GL-80-71

IE Bulletin No. 80-20
Page 1 of 2

FAILURES OF WESTINGHOUSE TYPE W-2 SPRING RETURN TO NEUTRAL CONTROL SWITCHES

FIGURE 1

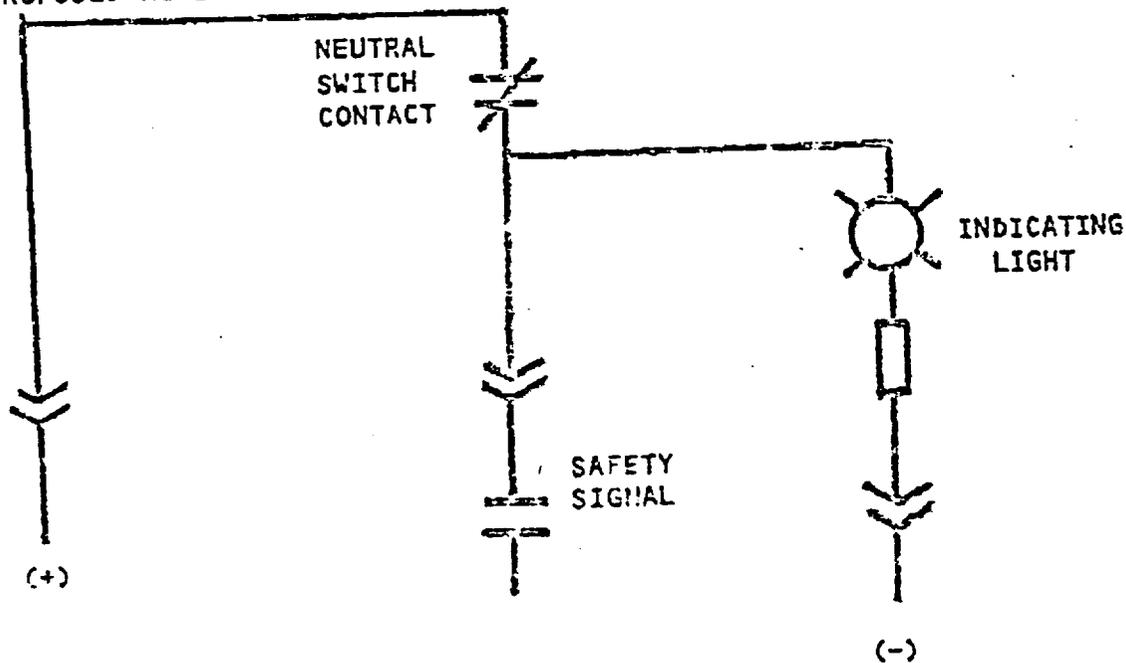
A review of this matter by Westinghouse led to the issuance of NSD Technical Bulletin No. NSD-TB-80-9 to the utility owners of all Westinghouse operating plants. The recommendations contained in the Westinghouse technical bulletin include: (i) testing the neutral position contacts of the subject W-2 switches for continuity, and (ii) rewiring of the indicating light circuit to permit the early detection of a neutral contact failure as shown in Figure 1.

Depending on how the indicating light circuit is wired, loss of continuity thru the neutral position contact of a W-2 switch could remain undetected until the equipment associated with the switch were called upon to operate. Since such a failure would be equivalent to by-passing the system associated with the switch, consideration should be given to rewiring the switches used in safety-related applications as shown in Figure 1. Such rewiring would provide an acceptable means for detecting contact failure, provided the indicating light is in the control room and readily visible by the operator. If the indicating light is not so located, consideration should be given to annunciating the neutral position contact failures at the control room to alert the operator of the inoperable status of a safety-related system. In addition, consideration should be given to adding redundant contacts to the W-2 switches or to replacing the W-2 switches with others having a more positive contact wiping action.

3. Licensees of operating plants and holders of construction permits shall describe the longer term corrective measures planned and the date by which such measures will be implemented by actual installation or by design change, as appropriate. As a minimum, the longer term corrective measures should include rewiring the indicating light as shown in Figure 1 provided the light is readily visible to the control room operator. If not, failures of the neutral position contacts should be annunciated in the control room.

REWIRING OF INDICATING LIGHT CIRCUIT OF W-2 SWITCHES
AS RECOMMENDED BY WESTINGHOUSE TECHNICAL BULLETIN NSD-TB-80-9
